Delegated Report

Householder Planning Application

Application No:	20221165
Location:	68 Jubilee Crescent, Gravesend, Kent, DA12 4JH
Description:	Removal of existing low brick wall, in order to produce sloped drive towards front of dwelling
Applicant:	Mr Dieudonne Uwera
Site Visit:	N/A Desktop Assessment

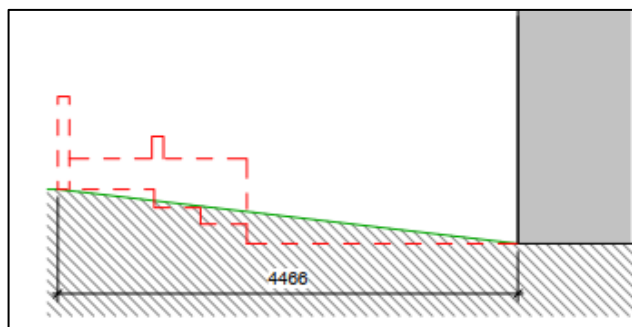
Considering the angled parking space, this is where the application fails. The short side of the parking space is considerably less than the 4.8 metres to safely accommodate a parked vehicle and is totally unacceptable.

The perpendicular space (1) has a depth of 4.8m and a width of 2.76m. The angled space (2) has a

maximum depth of 4.84m, a minimum depth of 3.45m and a width of 2.4m. Due to the topography, the driveways will be sloping down toward to the property.

Gravesham's Highways Officer has recommended that the application is refused by virtue of the substandard angled space (2) being contrary to local and national guidance. The comment also queried the gradient of the parking spaces and the potential of vehicles grounding as a result, however this is not considered to be a material planning consideration and is not relevant.

Overall, the proposed development is unacceptable and contrary to highway policy, by virtue of providing a substandard parking space that would result in vehicles overhanging the footway and boundary of the property. Therefore, the development is contrary to Gravesham's adopted parking standards SPG4 (2006), Kent County Council vehicle crossing guidance (2021), as well as Policy CS11 (LPCS) and saved policies T1 and T5 of Gravesham's Local Plan First Review (1994).
